Access Compliance Report

Public Rights-of-Way

Intersection ID: 23044	Main Street: CARMEL_RD	Cross Street: CROSSGATE_RD	Location:	N
ADA ID: B94B811C3BB6	Ramp Type: PerpDiag	Initial Pass/Fail: Fail	Overall Compliance: No	Severity Score: 13.75
Codes/Mitigation Info/Possible Solution		Field Measurements/Component Compliance

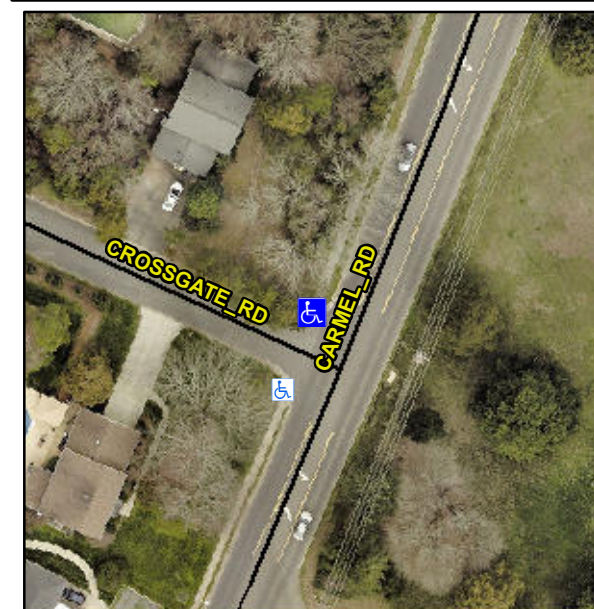
Not Found, R304.2.2, R304.5.3

Compliance	Description	Data	Compliance	Description	Data
N/A	Ramp Length (in)	58.0	No	Ramp Slope (%)	8.9
Yes	Ramp Width (in)	48.0	No	Ramp XSlope (%)	2.6
N/A	Flare Type LT	N/A	N/A	Flare Type RT	N/A
N/A	Flare Slope LT (%)	N/A	N/A	Flare Slope RT (%)	N/A
N/A	Flare Traversable LT?	N/A	N/A	Flare Traversable RT?	N/A
N/A	Landing Length (in)	N/A	N/A	DWS Provided?	N/A
N/A	Landing Width (in)	N/A	N/A	DWS Contrast?	N/A
N/A	Landing Slope (%)	N/A	N/A	DWS Length (in)	N/A
N/A	Landing X Slope (%)	N/A	N/A	DWS Full Width?	N/A
N/A	Landing Curb? (Y/N)	N/A	N/A	DWS Offset (in)	N/A
N/A	Shared Landing?	N/A			
N/A	Gutter Ponding?	N/A	N/A	Gutter Slope (%)	N/A
N/A	Gutter Lip Ht (in)	N/A	N/A	Gutter X Slope (%)	N/A
N/A	Painted X Walk1?	No	N/A	Painted X Walk2?	No
	X Walk 1 Direction	To SE		X Walk 2 Direction	To NE
N/A	X Walk 1 Width (in)	N/A	N/A	X Walk 2 Width (in)	N/A
	X Walk 1 Slope (%)	0.1		X Walk 2 Slope (%)	4.6
	X Walk 1 X Slope (%)	7.5		X Walk 2 X Slope (%)	1.1

Remove & Replace Curb Ramp With Two New Directional Ramps or Equivalent.
